Hydraulic Modelling Addendum

Job Name Peartree Hill Solar Farm

Job number 20-206

1.1.1 This Technical Note discusses additional work carried out to support proposed Solar PV development at Peartree Hill following the Environment Agency (EA) review of the development proposals and hydraulic modelling. It forms an addendum to the Peartree Hill Solar Farm Hydraulic Modelling Report 20-206-60-050.

4 HN21

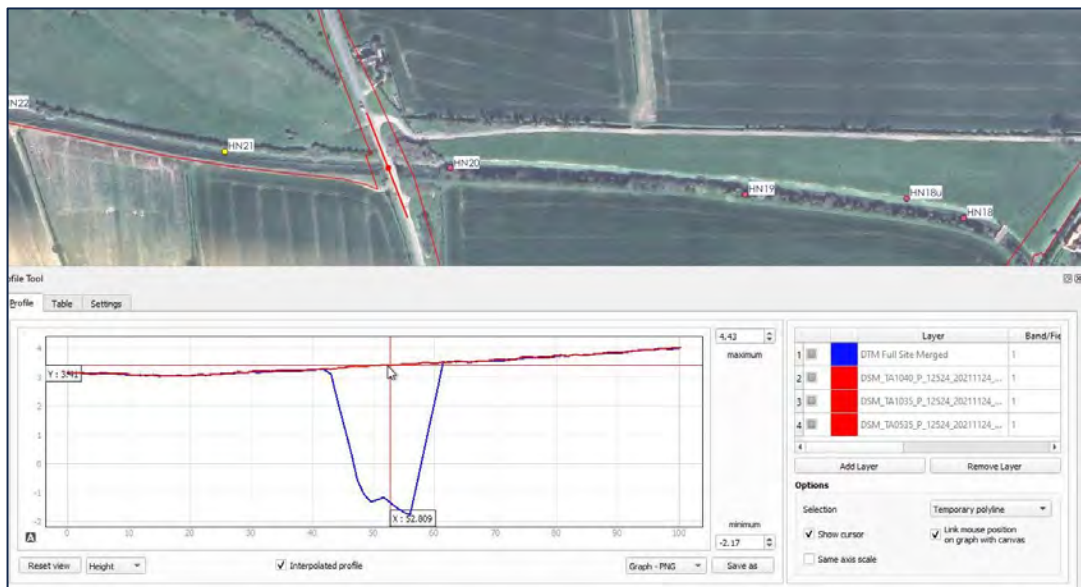
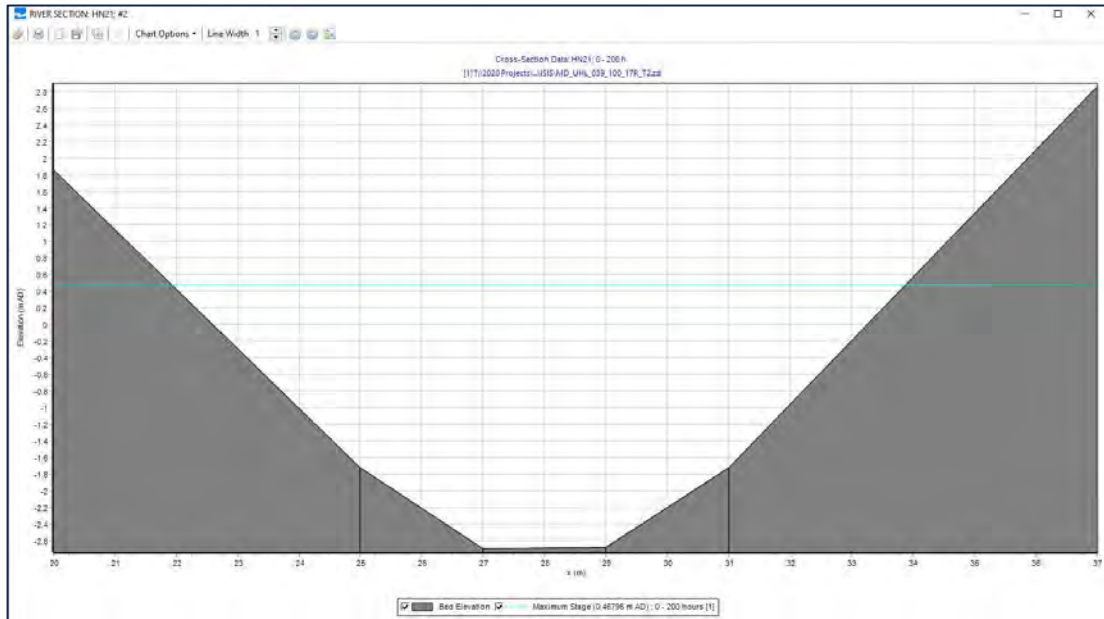
- 4.1.1 There is no bridge in the model between nodes HN21 and HN22 which is located adjacent to Parcel F6. The structure appears to be a flat deck, clear-span bridge as shown below

4.1.2 LiDAR data reports the bridge deck to be 3.25-3.5m AOD as shown below.

4.1.3 The maximum water level during the design event flood at node HN21 just upstream of the structure is 0.5m AOD as shown below. Consequently the soffit is likely to be much higher than the peak water level. The structure would therefore not impede flow and has not been added to the model.
